## Debugging after TI Comments-

### Glitch due to 220uf-

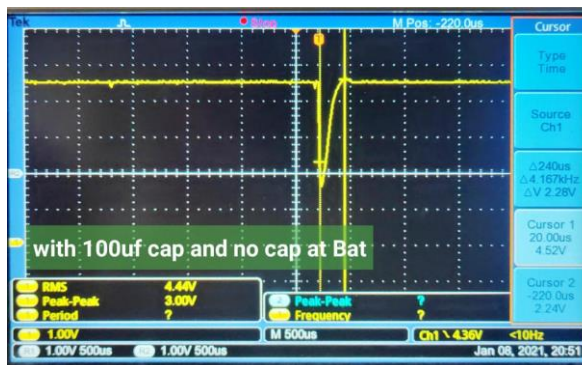
**TI Comment-** It looks like this glitch would be due to the 470uF cap charging with the MOSFET switch being turned on.

This cap value (470uF) was miss-written. Actual value is 220uf which has been reduced & removed to check impact of surge current-

- With decreasing cap, glitch amplitude does not decrease
- Without cap also, glitch comes.

It seems surge current of Tantalum cap is not impacting much on glitch.

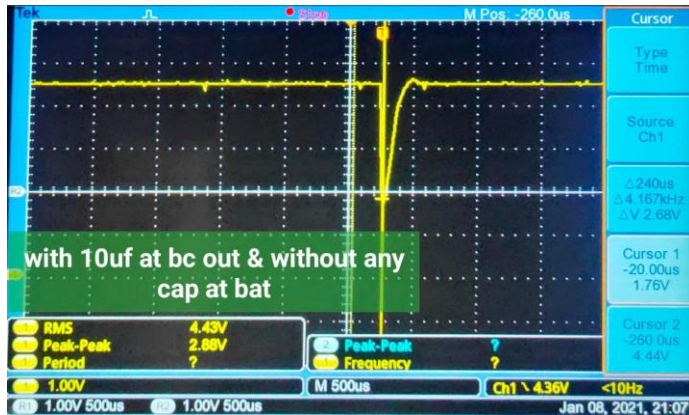
**TI Comment-** With the schematic, this problem may be reduced with capacitors (0.1uF minimum) that are required on the IN and OUT pin.

**P Gupta Comments-** We kept 0.1uf with 10uf at Input and output which is not impacting much on glitch amplitude
